ZONING BOARD OF APPEALS

Subject: Materials for April 1, 2020 Public Hearing

In response to questions raised at the Zoning Board of Appeals public hearing on February 5, 2020, the Planning Department is providing the following information for the upcoming continued public hearing/working session. This information is supplemental to staff analysis previously provided at the public hearing.

The intent of this memorandum is to provide the City of Newton with a peer review of the Residences on the Charles proposed redevelopment located at 15 Riverdale Avenue, Newton, MA. The Applicant is proposing to develop two separate buildings located to the north and south of Midland Avenue. HW reviewed the open space and building massing, and drainage report. A Sustainability Report has not been provided for review at this time.

Image 2. Revised Courtyard Plan

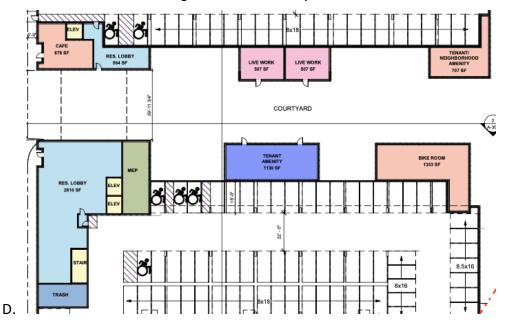
A key focal point and unique design feature of the project is the bridge that connects the two wings of Building 1. The bridge has been revised to be enlarged and lit, however, Planning Staff thinks there is more that could be done to further enhance the bridge as a focal point and visual connection to the Charles River. Planning Staff has concerns regarding the bridge acting as a visual barrier to the courtyard due to the units that are located within the bridge, and that the bridge is four stories in height. Planning suggests the applicant consider removing the residential units located within the bridge, or removing the bridge at lower floors and only connect at a higher floor to achieve visual transparency.

Another opportunity for an enhanced streetscape are the lobbies that border the courtyard of Building 1. The Planning Department supports the design feature at the corner of Building 2 as a prominent corner to draw the eye and invite the public towards the Courtyard. Staff suggests the petitioner to consider a similar element to Building 1.
